14. DESCRIPTION OF AMENDMENT/MODIFICATION (Organized by UCF section headings, including solicitation/contract subject matter where feasible.)
THE ABOVE REFERENCED SOLICITATION FOR THE LOCKER ROOM RENOVATION AT THE DENVER ARTCC IS AMENDED AS FOLLOWS:

RFO: DTFANM-11-R-00062

Locker Room Renovation at the Denver ARTCC in Longmont, CO

AMENDMENT 0002

LOCKER ROOM AREA DEMOLITION PLAN

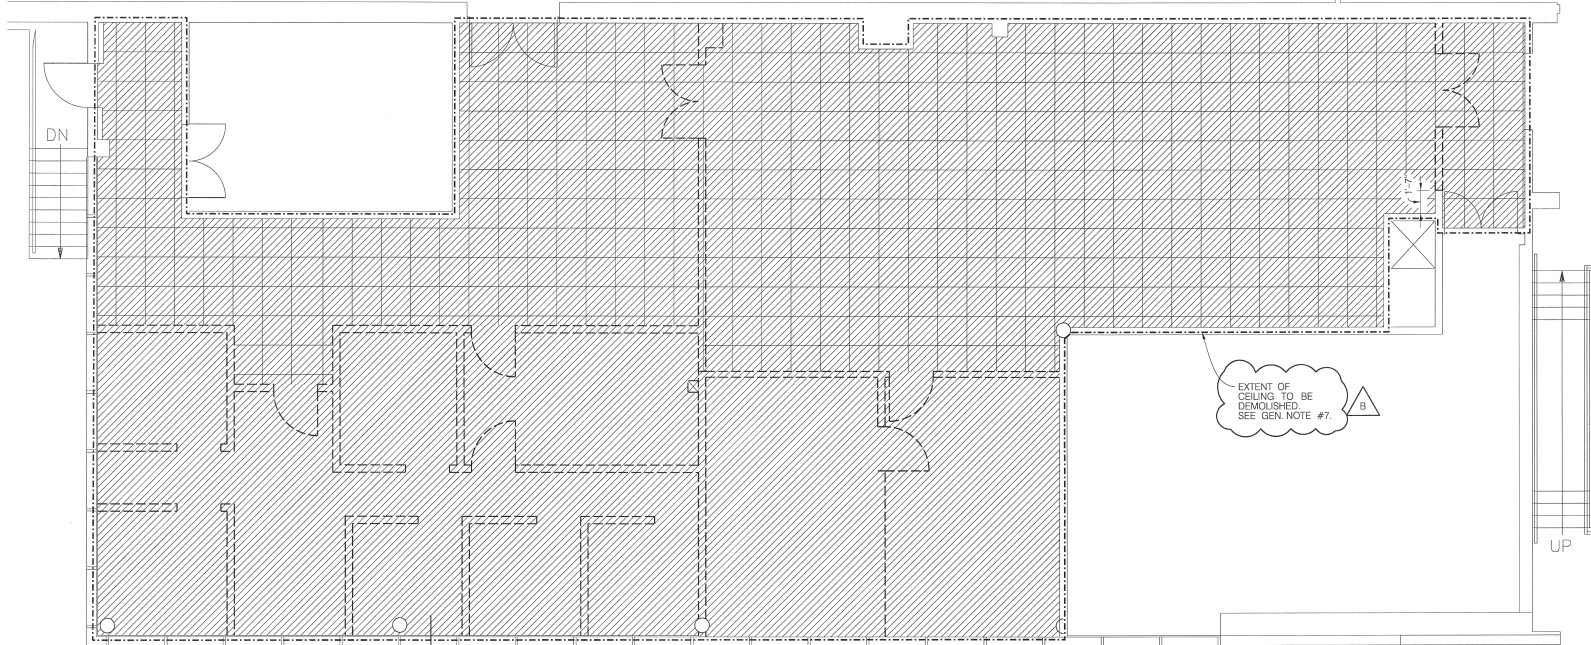
FOR OFFICIAL USE ONLY PUBLIC AVAILABILITY TO BE DETERMINED UNDER 5 USC 552									
REV	APPROVED DATE	DESCRIPTION	JCN	REDLINE DATE	APPROVED				
B	5/3/2011	REVISED LEGEND AND CEILING DEMO NOTE.							
A	01/11/2011	ADDED VCT ADHESIVE UPDATE TO LEGEND

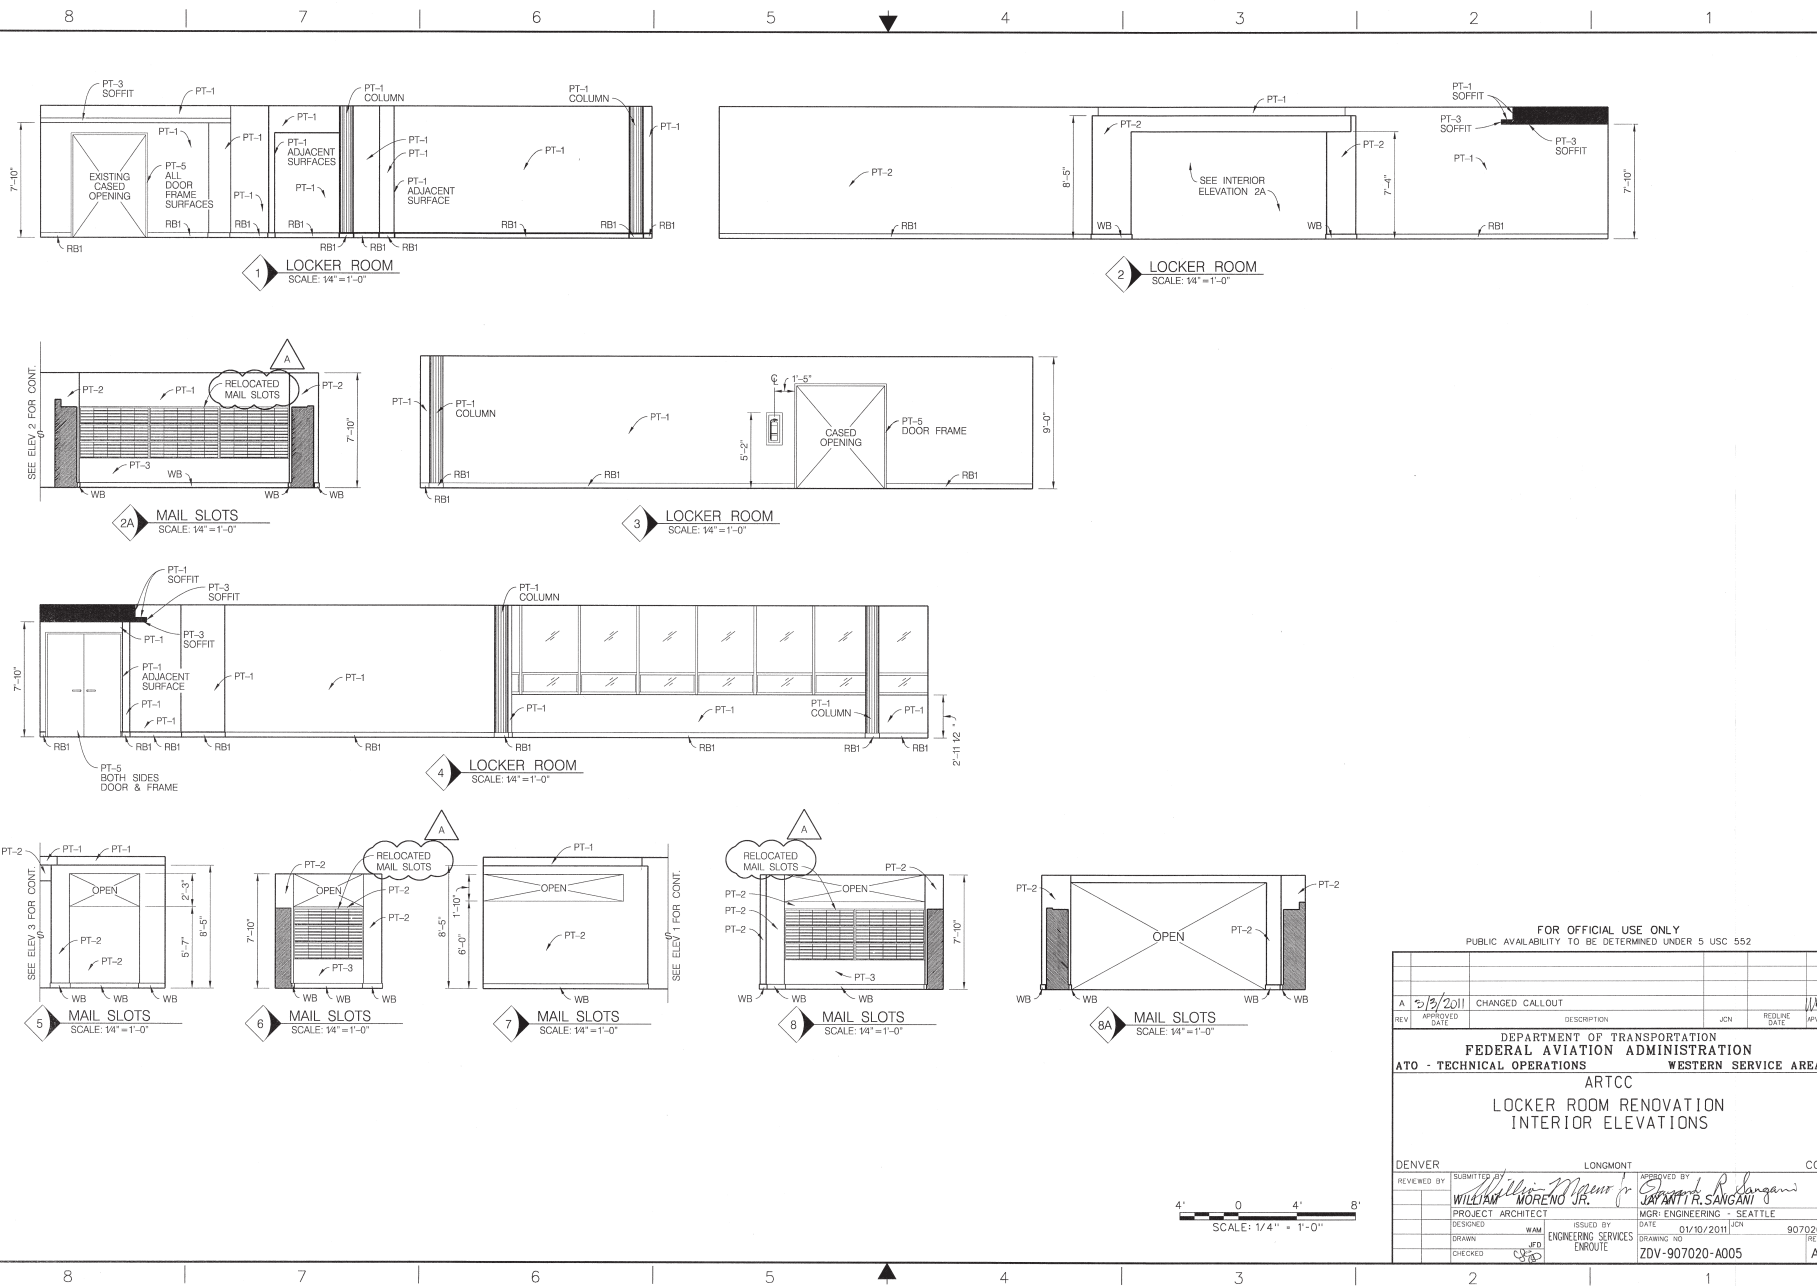
QUESTION #2: On A009 detail 5, it says to fur out the curtain wall 5' 3/8" tall ?

ANSWER: *No, it's actually 5- 3/8". However, that number is wrong. See the attached drawing revision.*
